Project	<b>IEEE 802.16 Broadband Wireless Access Working Group</b> < <a href="http://ieee802.org/16">http://ieee802.org/16</a> >
Title	<b>Proposal for BS Related NRM Definitions</b>
Date Submitted	<b>Ballot Comments for 802.16g/D1 Letter Ballot #20</b>
Source(s)	<b>2006-03-03</b>
Re:	Scott Migaldi 1303 East Algonquin Road Schaumburg, IL. 60196
Abstract	Letter Ballot#20
Purpose	To facilitate comments in the LB#20 commentary database
Notice	This document has been prepared to assist IEEE 802.16. It is offered as a basis for discussion and is not binding on the contributing individual(s) or organization(s). The material in this document is subject to change in form and content after further study. The contributor(s) reserve(s) the right to add, amend or withdraw material contained herein.
Release	The contributor grants a free, irrevocable license to the IEEE to incorporate material contained in this contribution, and any modifications thereof, in the creation of an IEEE Standards publication; to copyright in the IEEE's name any IEEE Standards publication even though it may include portions of this contribution; and at the IEEE's sole discretion to permit others to reproduce in whole or

### Comment # 3

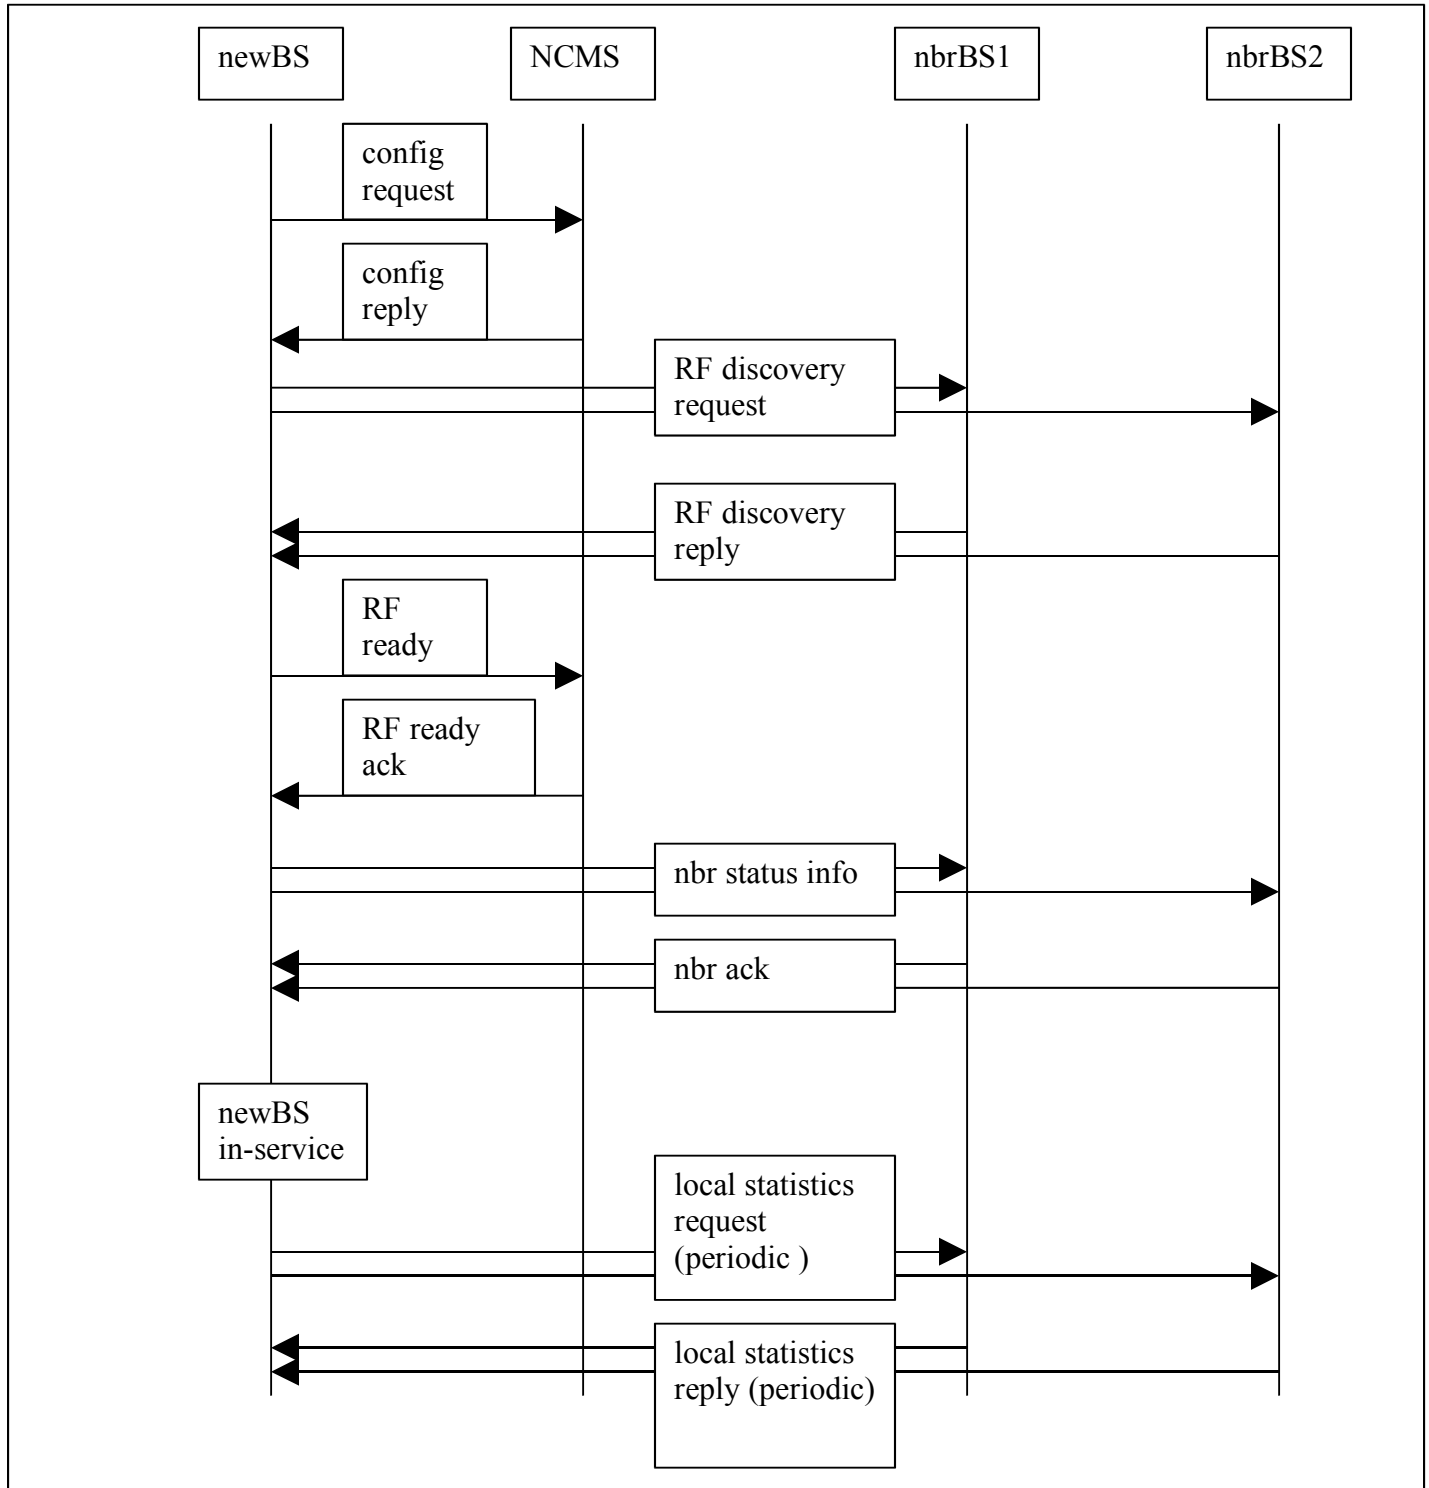
#### 14.2.2.7 BS Initiated Configuration Management

After getting start-up configuration file, a BS issues this primitive to NCMS to obtain permission to go in-service. It exchanges security information with the NCMS server.

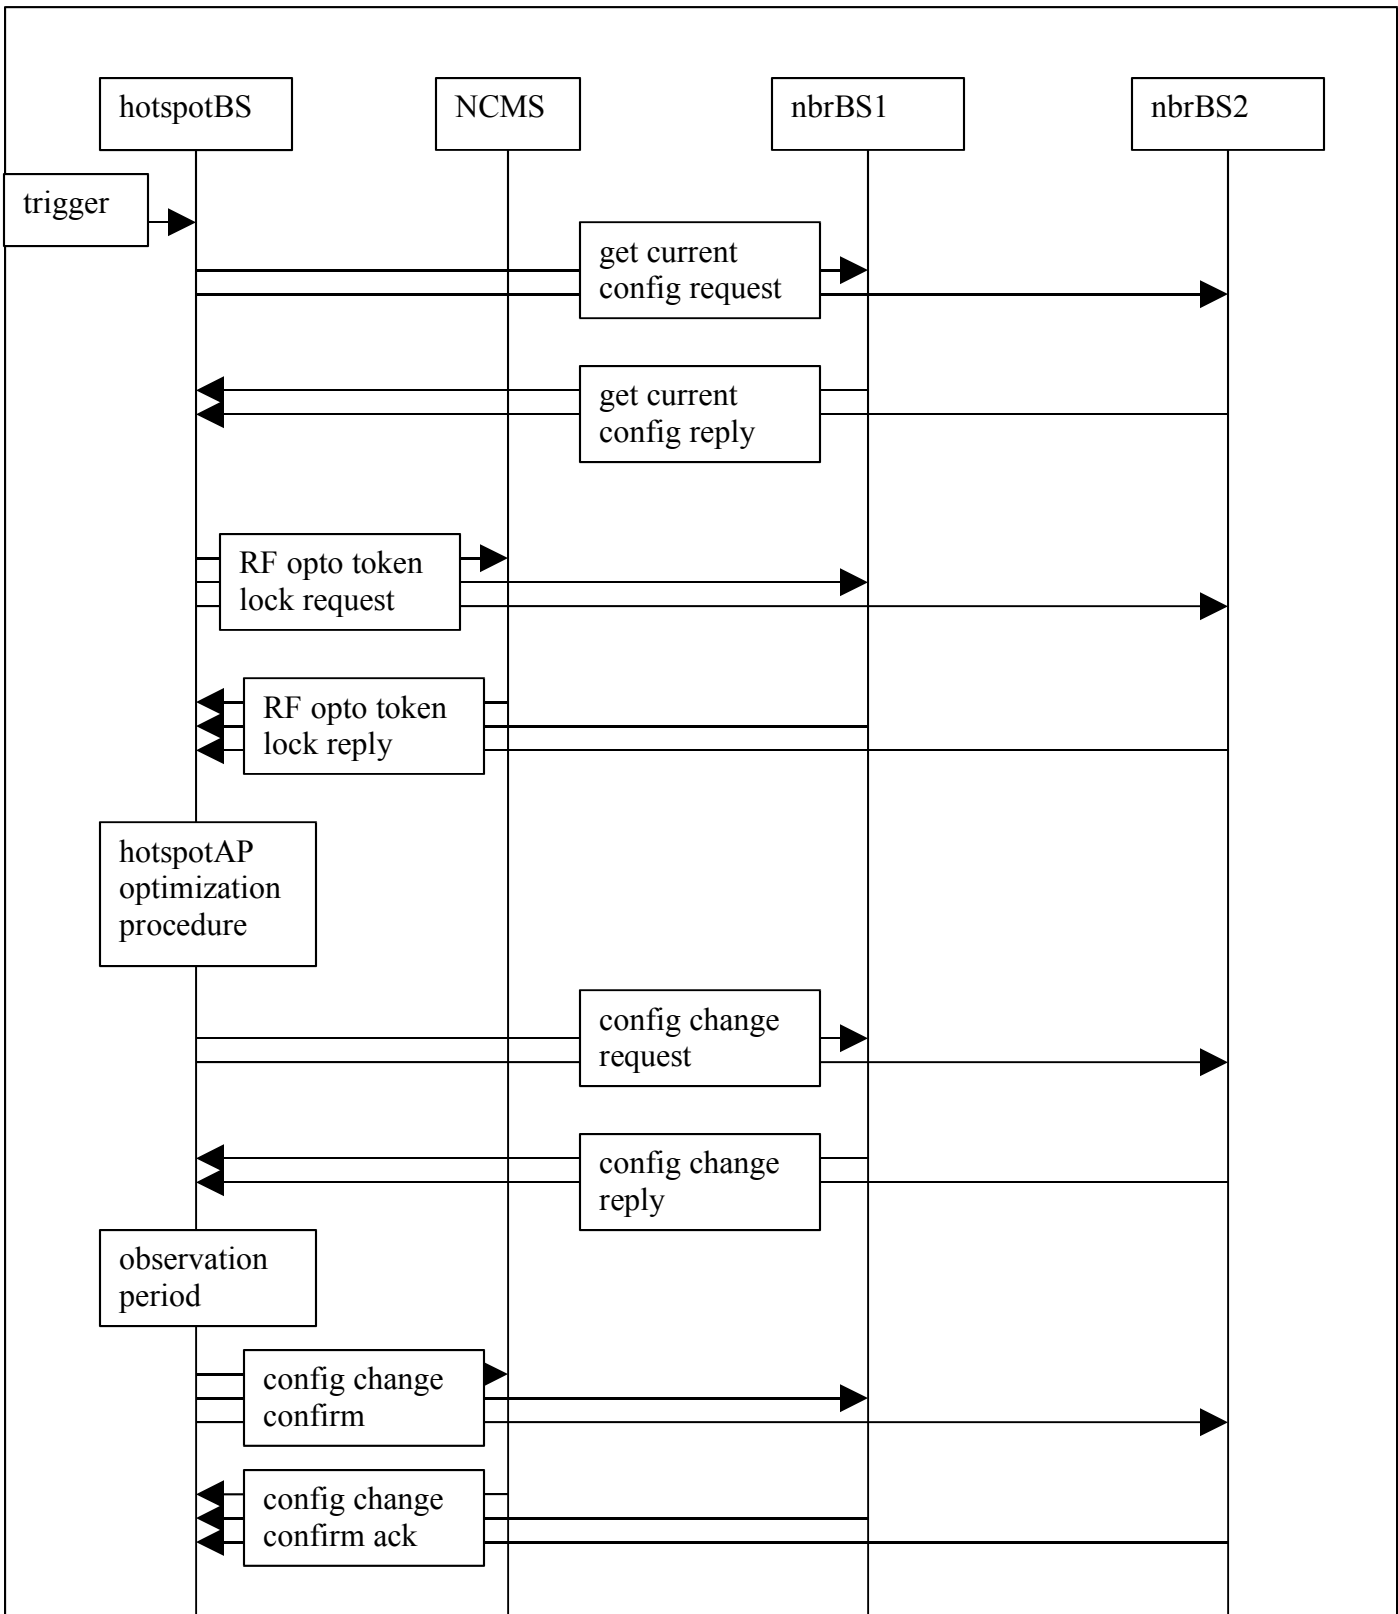
Effect of receipt

A BS that receives it updates its parameters etc.
